**Development Application:** Minor Change to Development Permit DA20/21-005 for Carrying Out Operational Work (External Road Works, Internal Road Works and Parking, Earthworks, Stormwater and Drainage Works and Water Supply Connection)

Referred to in Council's Decision Notice

# Thomson River Caravan Park Locality Plan

STORMWATER & DRAINAGE MANAGEMENT PLAN			
ENGINEERING CERTIFICATION (RPEQ)			
#	FIELD	NAME	DATE
13697	CIVIL	S. SHAY	23/08/21

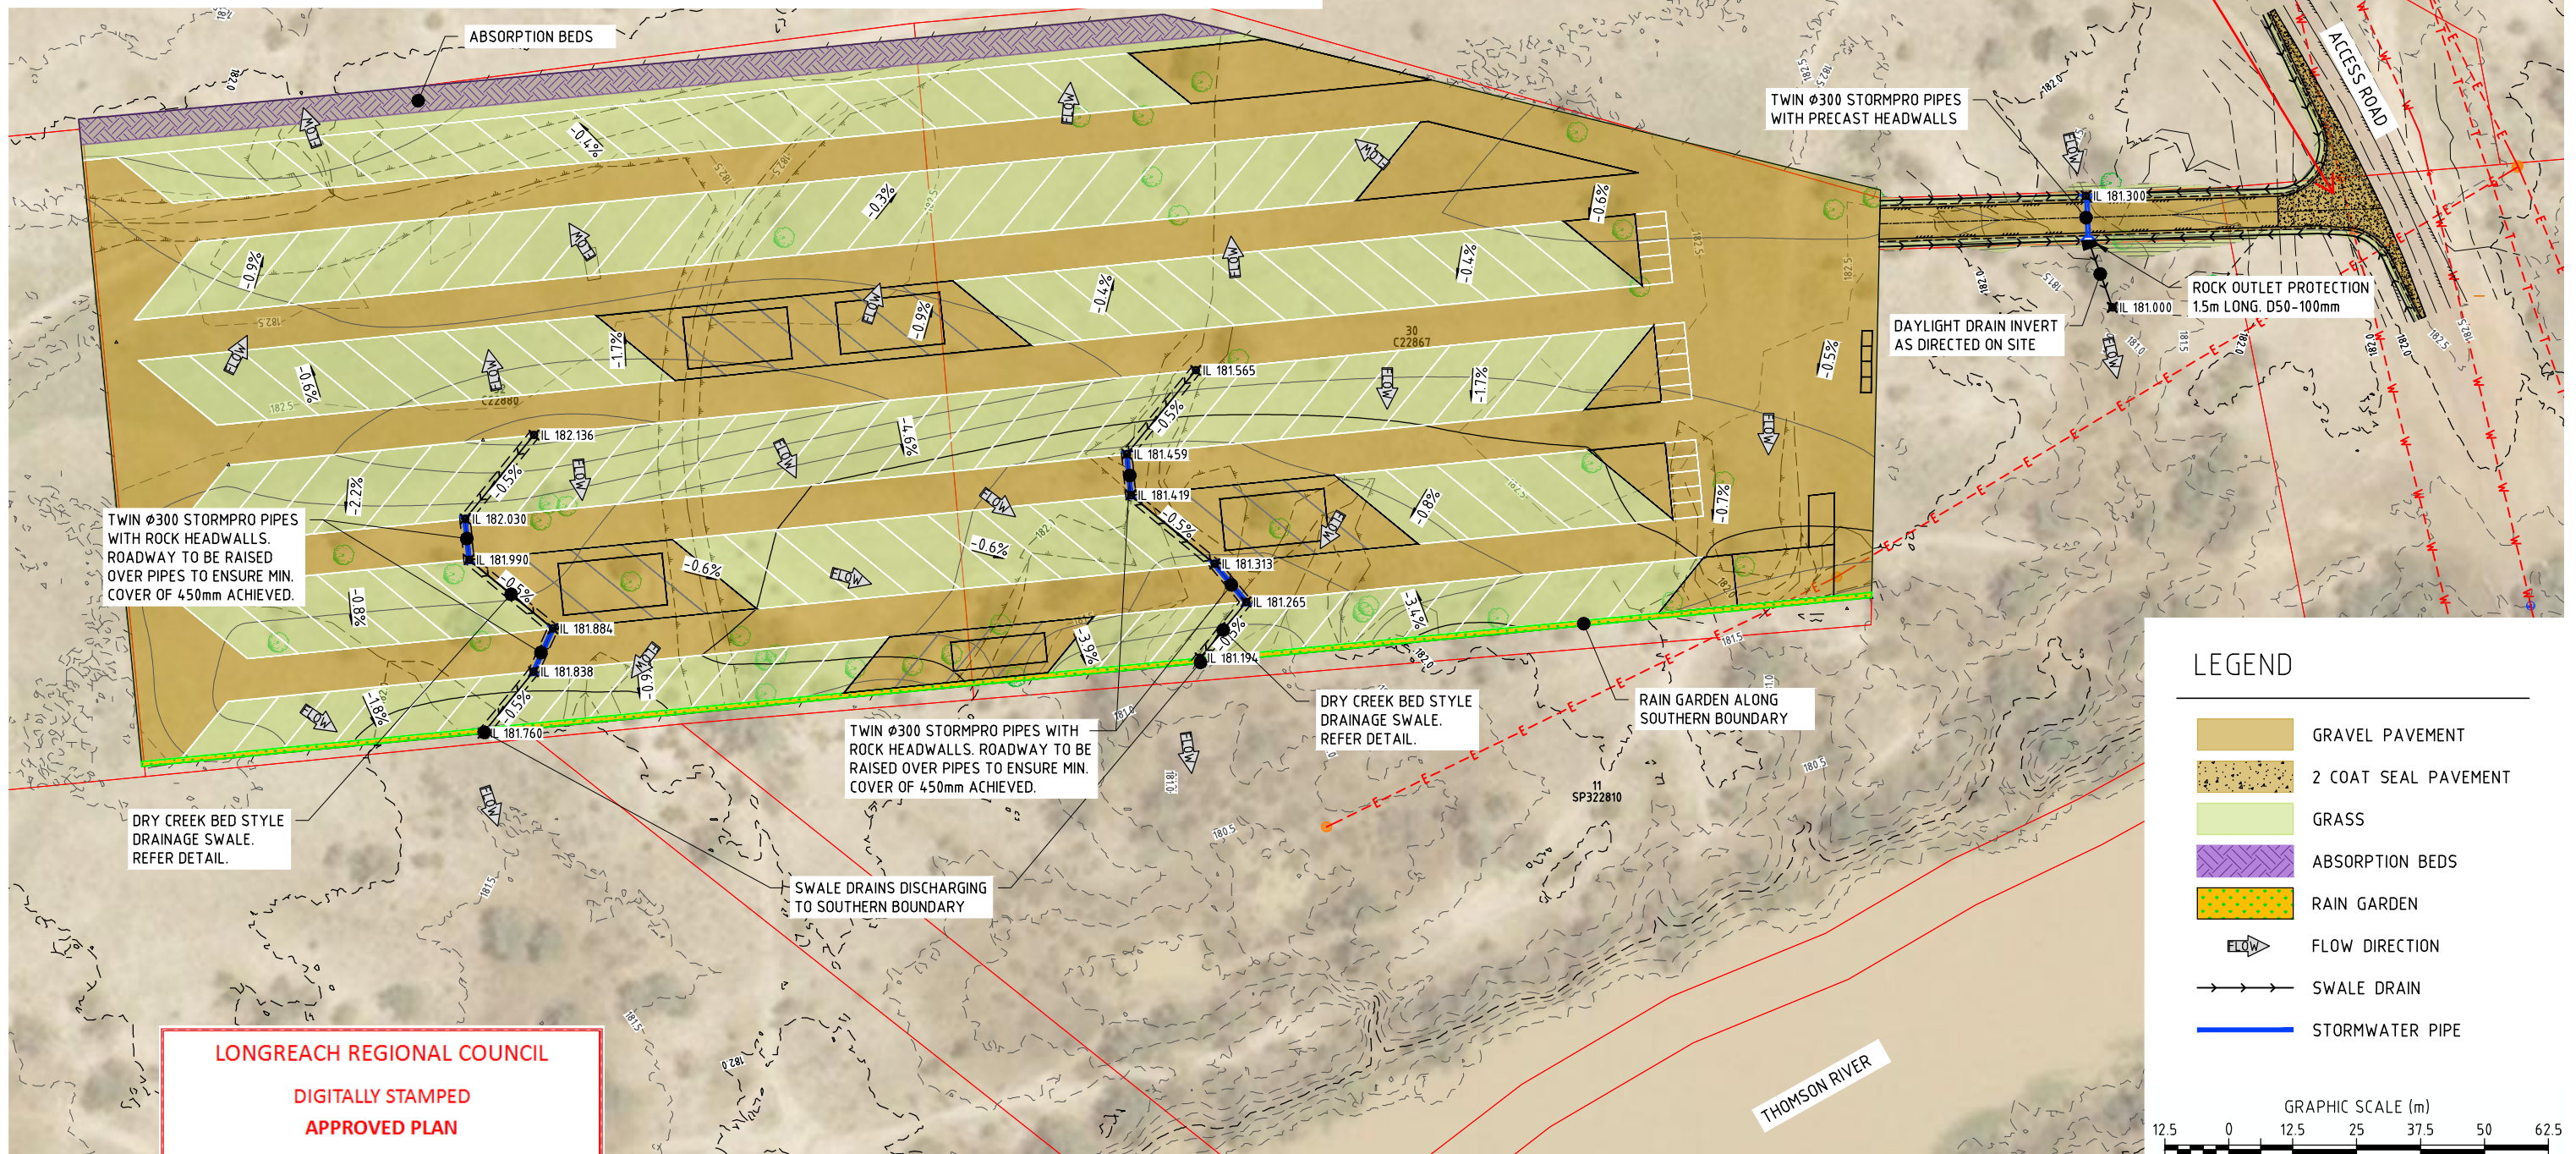
Amended in red by Council  
08/07/22

Access location to be in accordance with plan:  
Proposed changes with reference OPWC1 dated 27/04/22 (Received date)

WATER RETICULATION LAYOUT PLAN			
ENGINEERING CERTIFICATION (RPEQ)			
#	FIELD	NAME	DATE
13697	CIVIL	S. SHAY	23/08/21

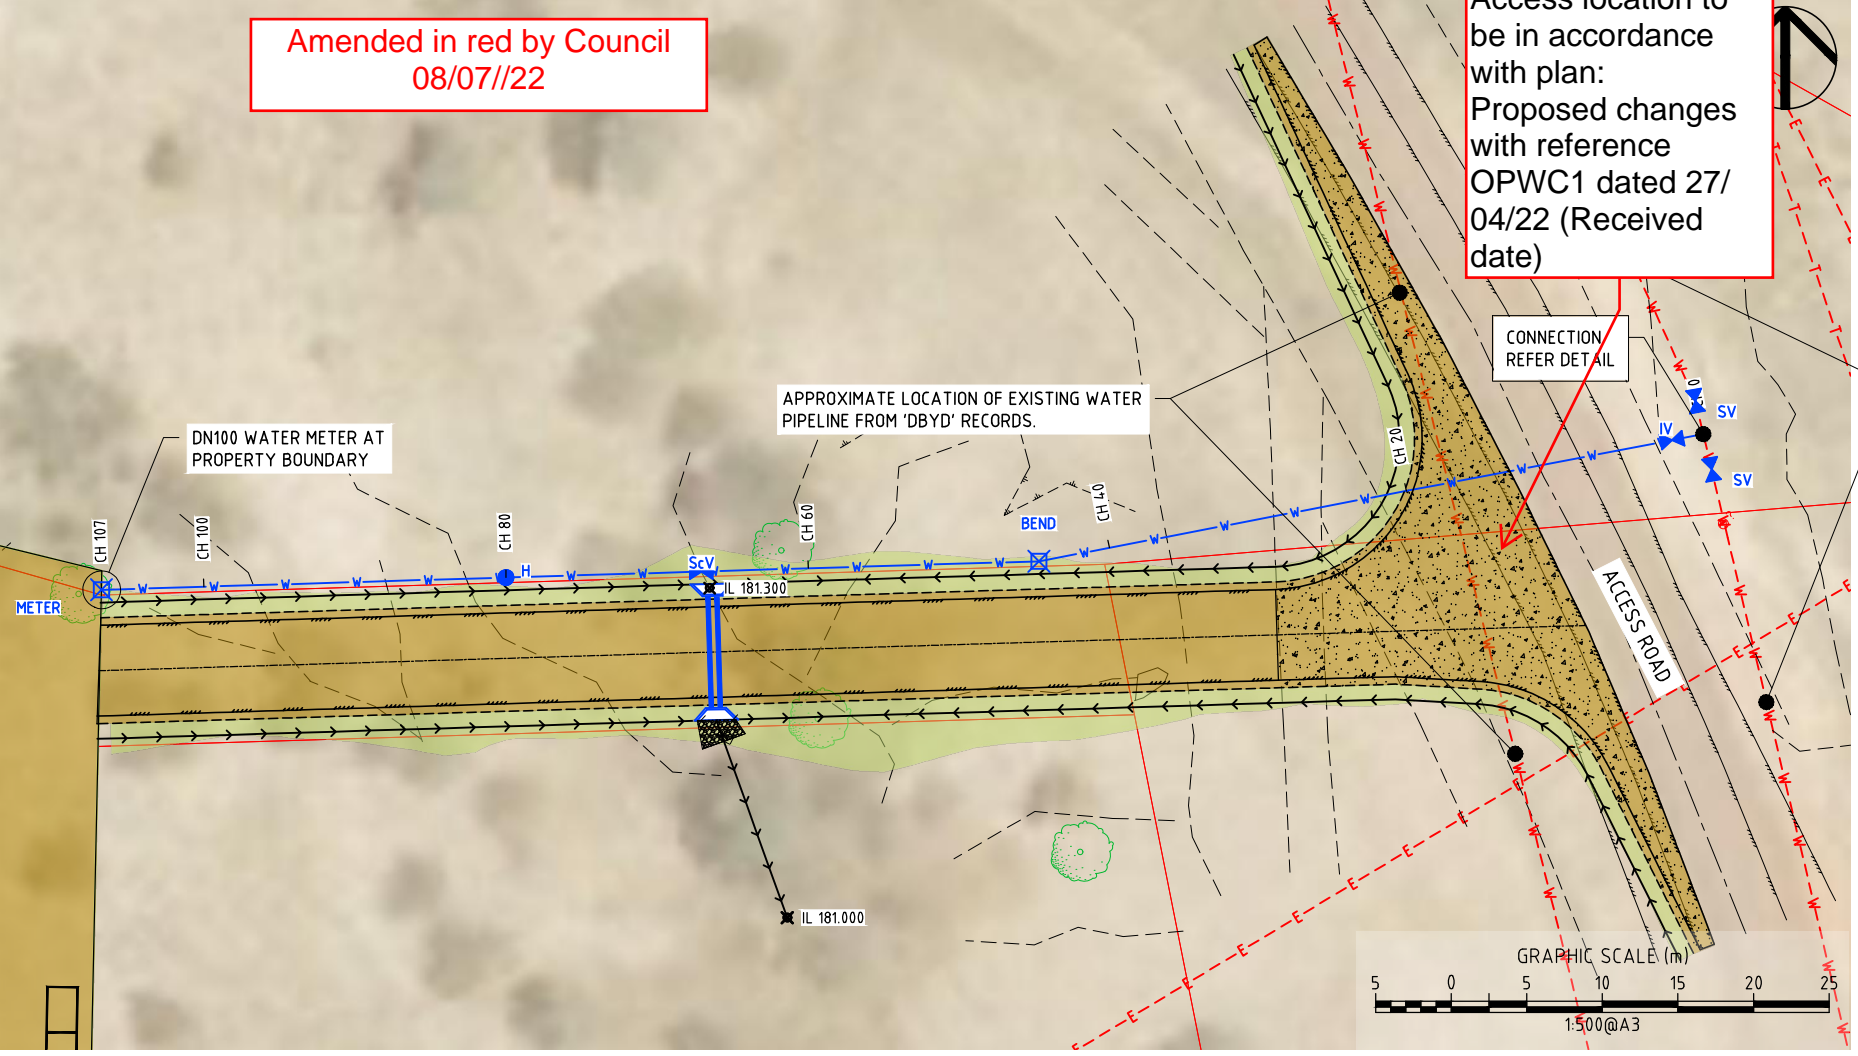
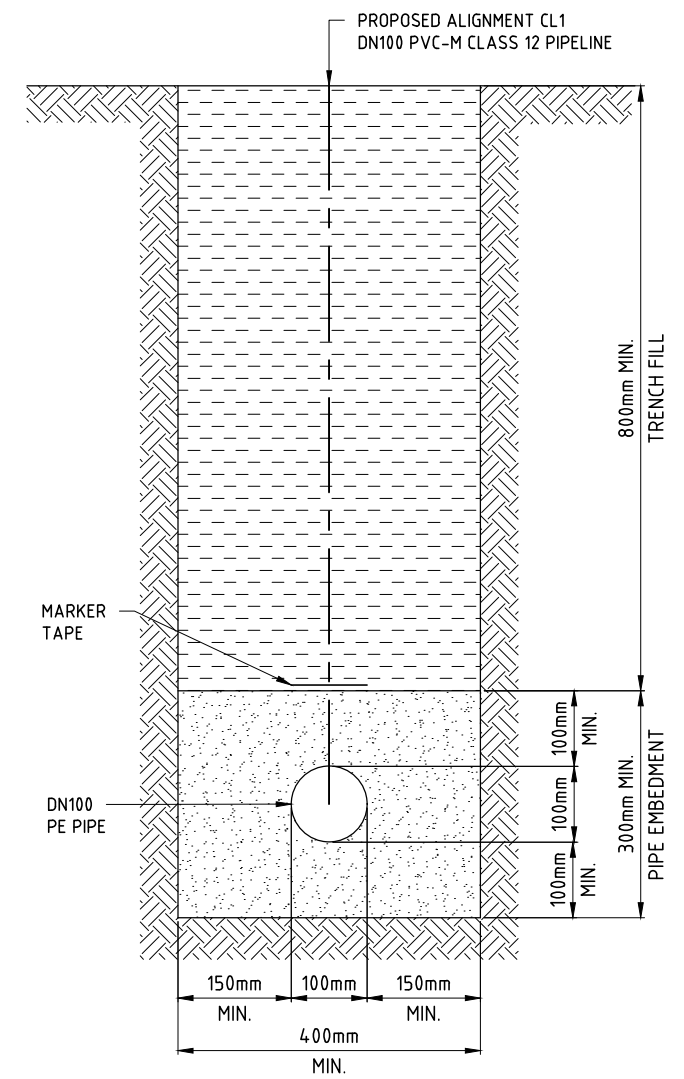
Amended in red by Council  
08/07/22

Access location to be in accordance with plan:  
Proposed changes with reference OPWC1 dated 27/04/22 (Received date)
